Memorandum

Subject: Development description Reconfiguration of a Lot for the land described as Lot 2 on RP223566, Lot 902 on SP108453, and Lot 390 on SP149355 located at Highfield Drive, Breakwater Road and Aquatic Drive, Robina and Merrimac - Council Application No.: PN158804/23/DA2 - RCU No.:1904 &/or ECOTRACK Project No: No records

IPA APPLICATION ASSESSMENT SHEET – CONTAMINATED LAND UNIT

Notice of concurrence agency response Sections 3.3.16 and 3.3.18 *Integrated Planning Act 1997*

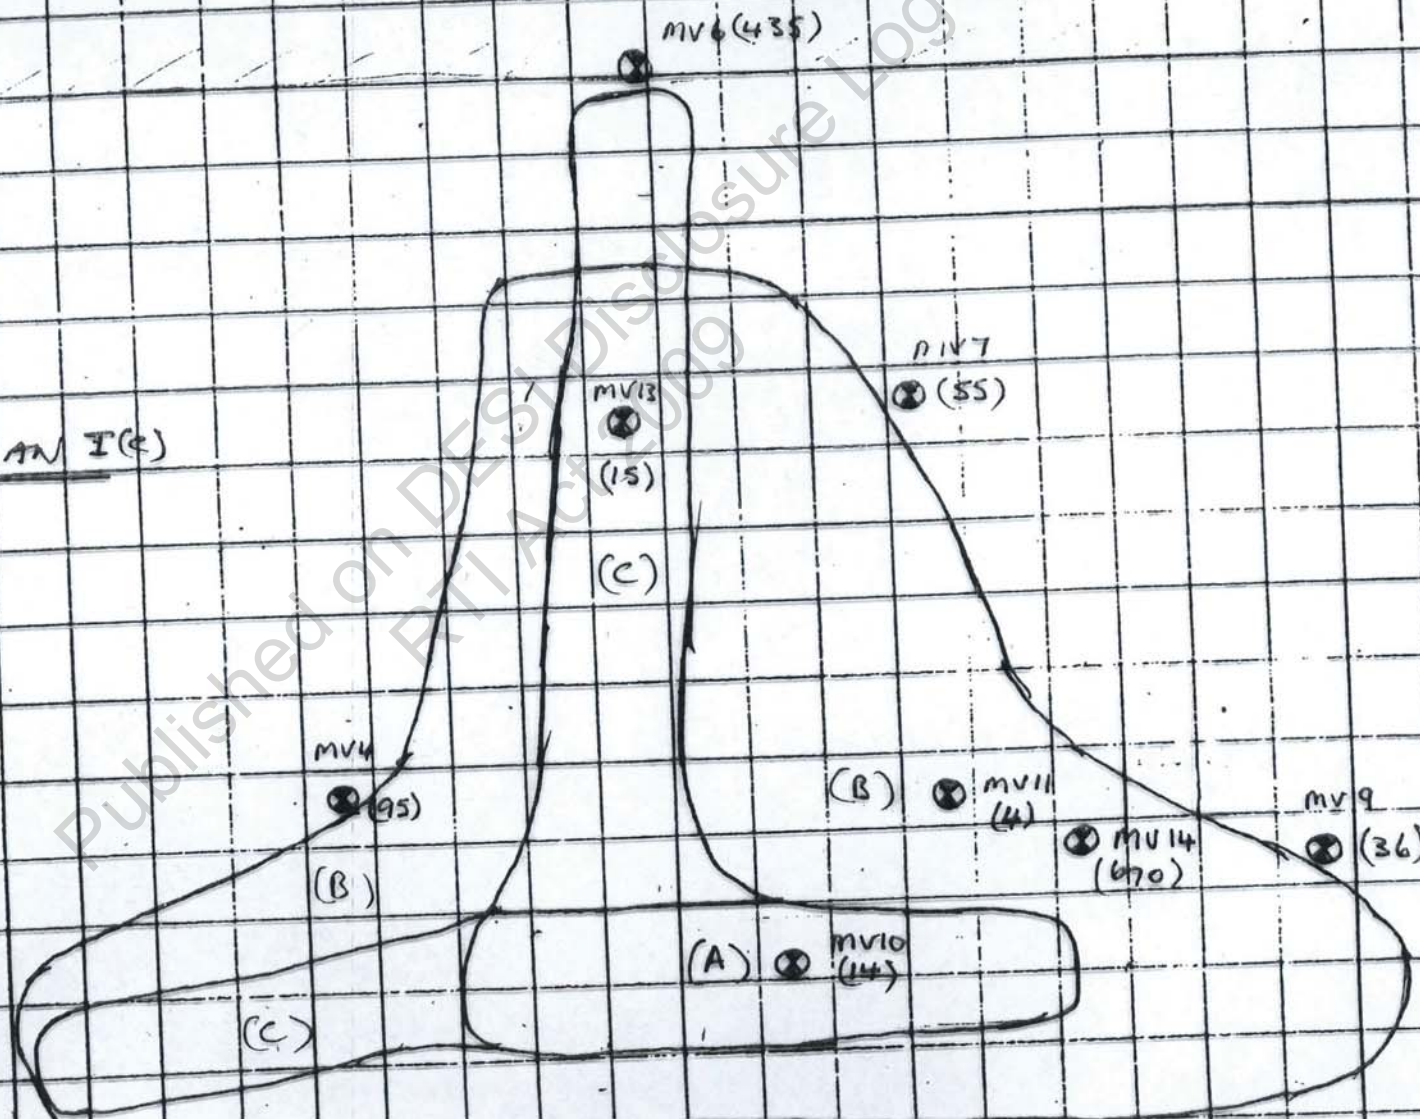
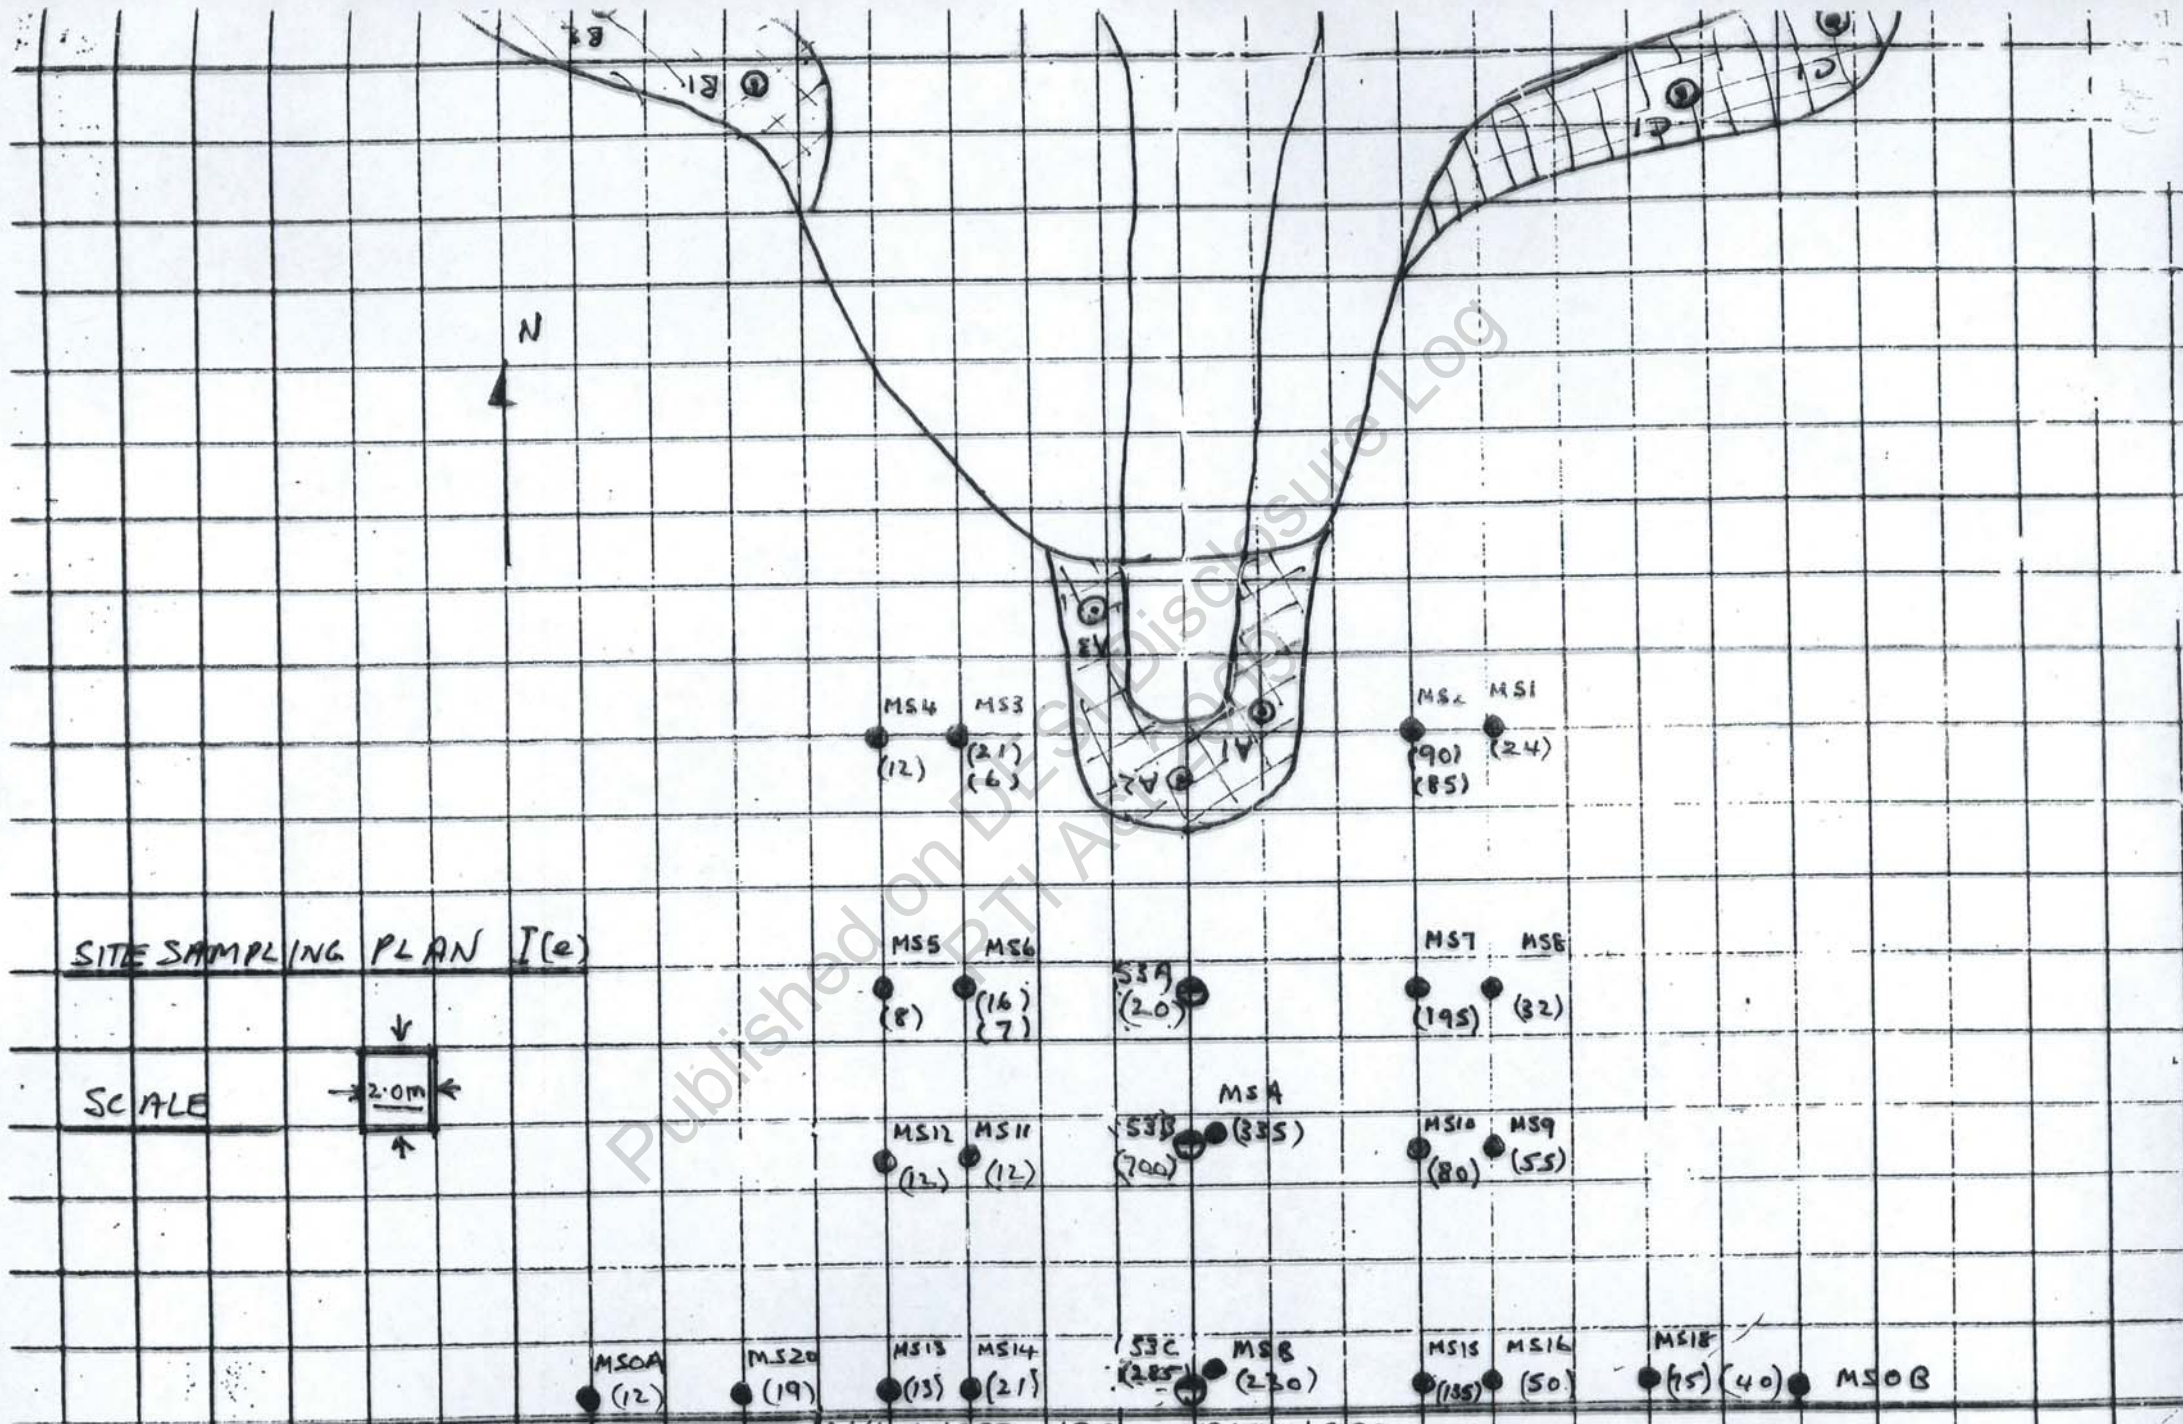
Greetings All,

Please be advised that the above application commencement advice ex DLGPSR was in this mornings fax-mail, with the hard-copy dataset ex DLGPSR delivered by Rohan. Attached is the response coversheet.

NOTE due date to me 18/7/2005
